Application No. 10/630,292  
Amendment dated August 26, 2005  
Reply to Office Action of August 2, 2005

**Amendments to the Drawings:**

FIG. 3

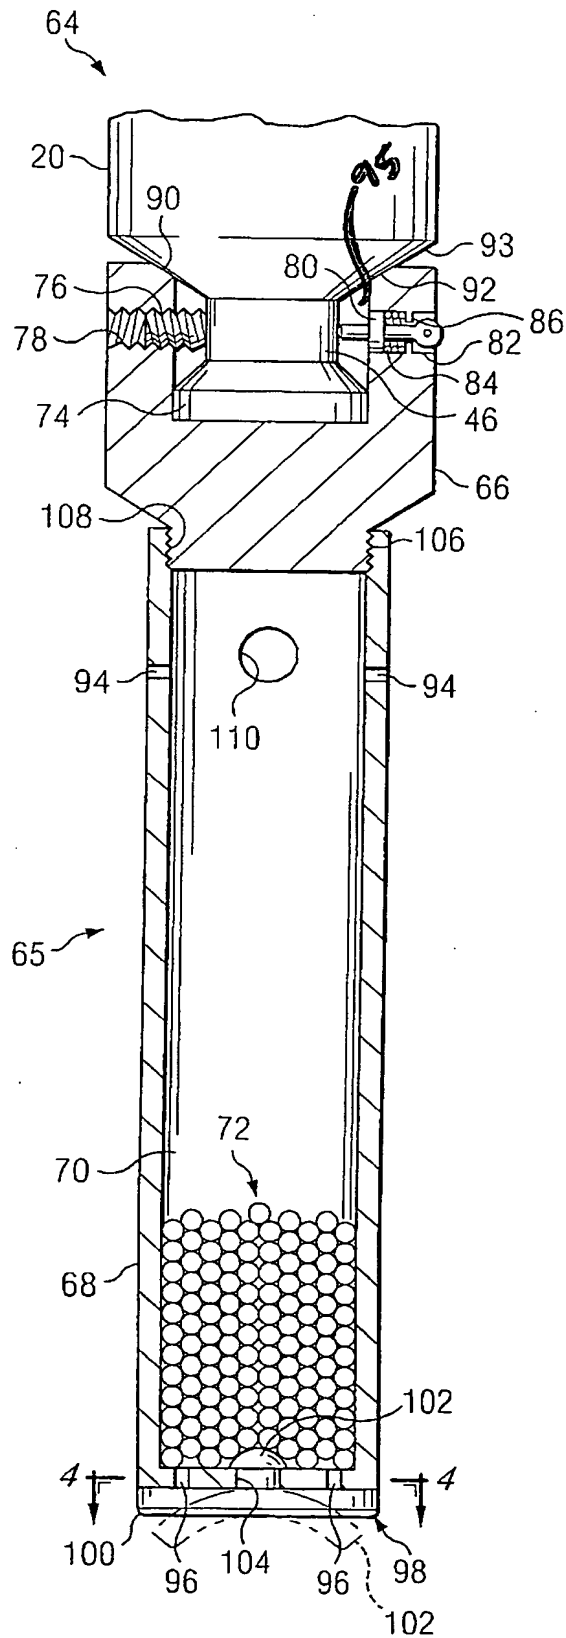
The attached sheet of drawings includes changes to Figs. 3 and 6. The change to Figure 3 adds reference number for the opening 95. The change to Figure 6 adds reference number 135 for the wall. The amendments to the drawings do not add any new matter, as all the amendments are supported by the original specification, claims, and drawings.
